Access Compliance Report

Public Rights-of-Way

Intersection ID: 28138	Main Street: BRYSON_BEND_DR	Cross Street: TAYLORFORD_PL	Location: NE
ADA ID: 6FEA5555381	Ramp Type: BlendTrans1	Initial Pass/Fail: Pass	Overall Compliance: No
Severity Score: 7.75			
Codes/Mitigation Info/Possible Solution		Field Measurements/Component Compliance

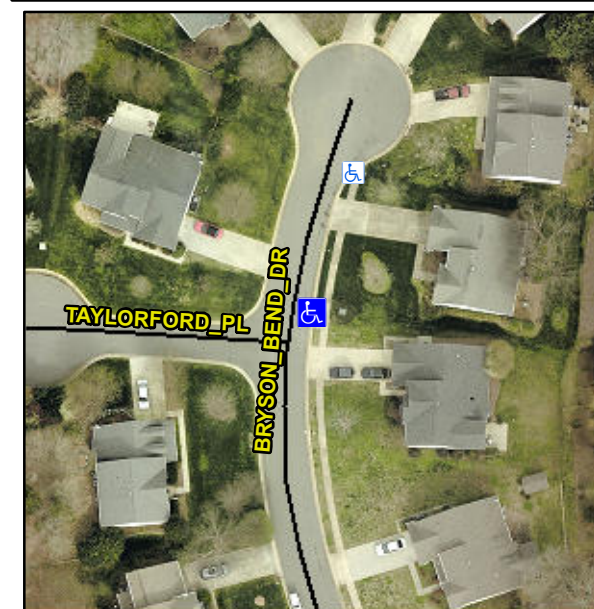
Remove & Replace Curb Ramp With Two New Directional Ramps or Equivalent. Remove & Replace Gutter.

Not Found, R304.5.3, R305.2, R302.7.2
